RE: COLUMBIA PRECINCT MAJOR PROJECT MP10-0143
CASE NUMBER 125121

FEASIBILITY LETTER

Developer:	P D MAYOH PTY LTD ARCHITECTS
Your reference:	72140/Columbia
Development:	Lot A DP 171468 (No.2-20) PARRAMATTA RD, Homebush
Development Description:	Concept Plan for construction of mixed use development
Your application date:	19 July 2011

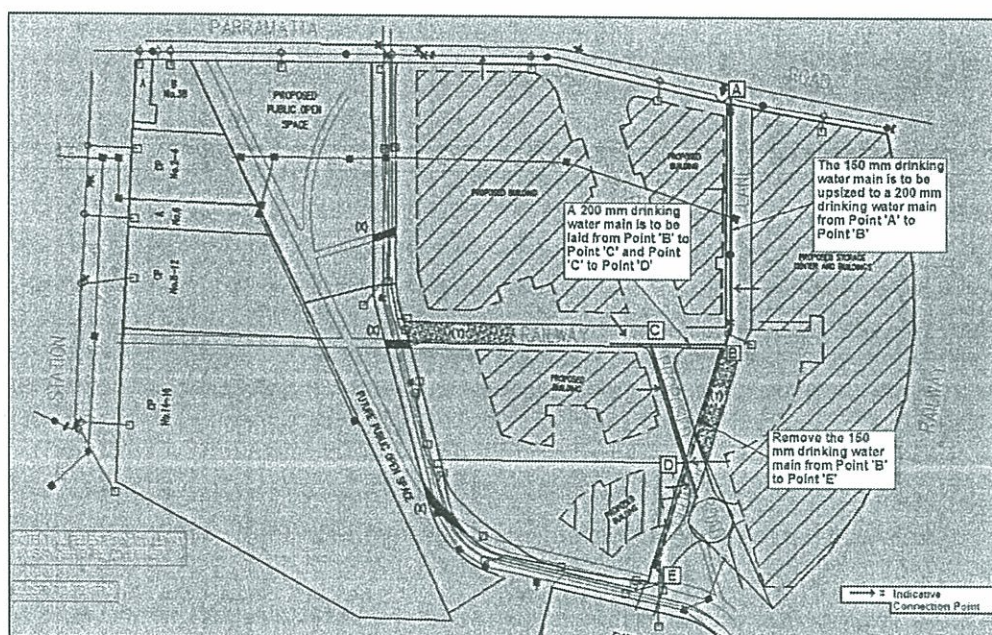
- The drinking water main available for connection is the 200 mm main on the Southern side of Parramatta Road. See concept plan below.
- The existing 150 mm drinking water main in Columbia Lane is to be upsized to a 200 mm drinking water main from Point 'A' to Point 'B'. See concept plan below.
- A 200 mm drinking water main is to be laid from point 'B' to Point 'C' and Point 'C' to Point 'D'. See concept plan below.
- The 150 mm drinking water main is to be removed from Point 'B' to Point 'E'. See concept plan below.
- The proposed drinking water infrastructure for this development will be sized & configured according to the Water Supply Code of Australia (Sydney Water Edition WSA 03-2002).
